Technical Note

Project Mayfield, Manchester
Subject Mayfield Site Compound
Project no 0046688
Date 23 November 2023

1 Introduction

Figure 2-2 The 2017 bat survey results plan of identified bat roosts within the wider Mayfield Development area.

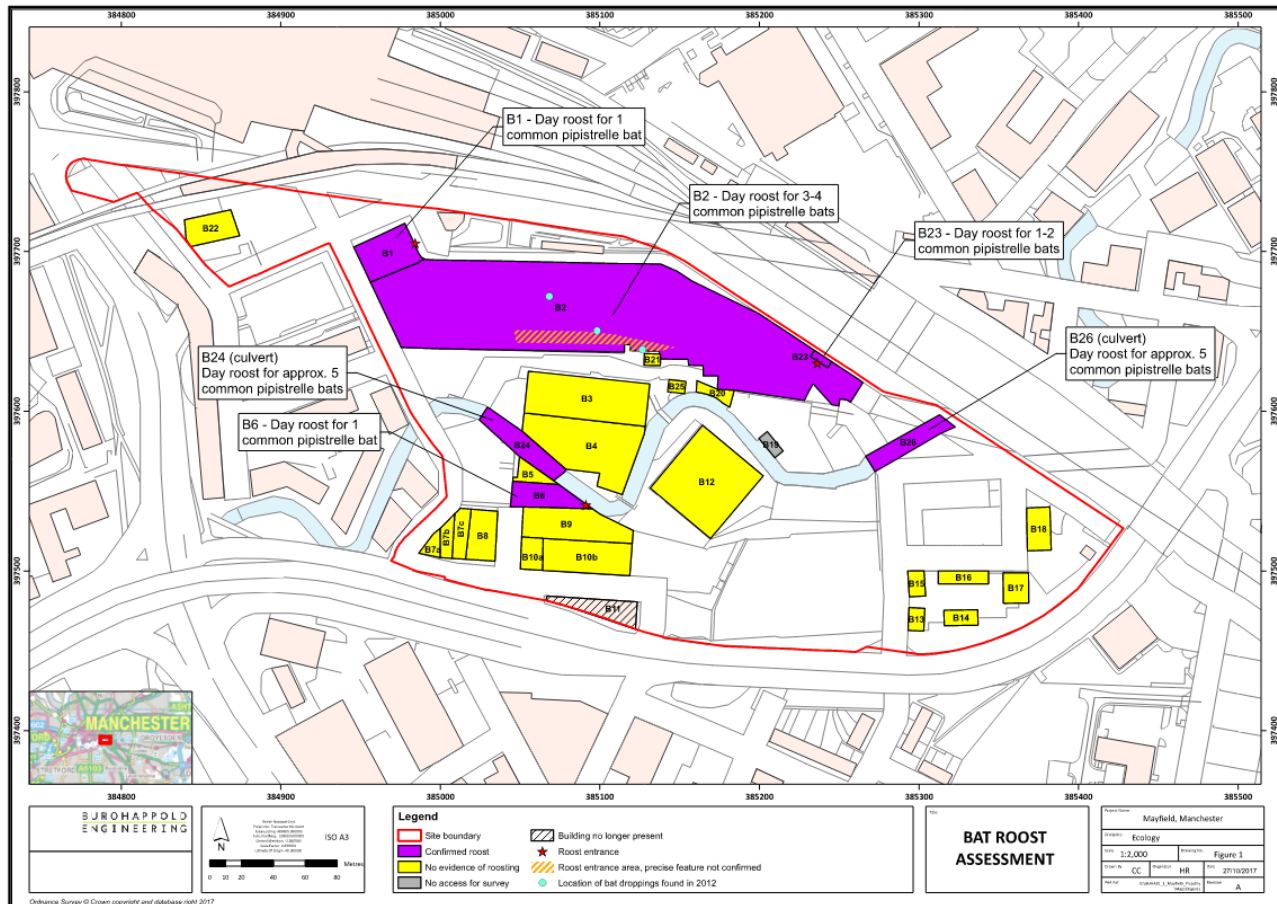
The bat assessment is dated 2016. This is no longer valid. Current guidance is that the maximum age of a report prior to a full resurvey is 3 years. Whilst the building were assessed as negligible risk, the buildings are not of a type with no risk. Bats also have been recorded roosting elsewhere on the Mayfield Site. Given Current guidance states it is essential that the presence or otherwise of protected species and the extent that they may be affected by the proposed development is established before the planning permission is granted (UK Government Guidance within the ODPM Government Circular 06/2005), I recommend that:

Prior to determination a updated bat assessment is carried out by a suitably experienced bat worker. The assessment should include as a minimum a visual inspection of the existing roof space for evidence of bats and exterior of the building for potential bat access points. Should the property be assessed as more than low risk, further information will be required prior to determination."

Previously, no evidence of roosting bats was found within the buildings that are on site, and the buildings were considered to offer negligible potential at the time of the previous survey (see Figure 2-2). The previous reports describe

The buildings on site were re-assessed for their potential to support roosting bats. As identified in section 2.1.3, buildings B13 – B18 fall within the site boundary, all of which were previously identified to have negligible potential to support roosting bats at the time of the 2017 bat roost inspection surveys.

Since the previous surveys, building B18 has been demolished. Buildings B13 – B17 were reassessed, and all were considered to continue to have negligible potential to support roosting bats. All buildings remain in use and have limited roosting opportunities internally or on the external elevations of the buildings. The construction type, with metal cladding on the upper portions of the buildings (Figure 2-9), provide little suitable roosting space. Where there is exposed brick in the lower sections of the elevations, the mortar is generally in good condition with no features identified that are likely to provide access to a suitable cavity space for roosting.
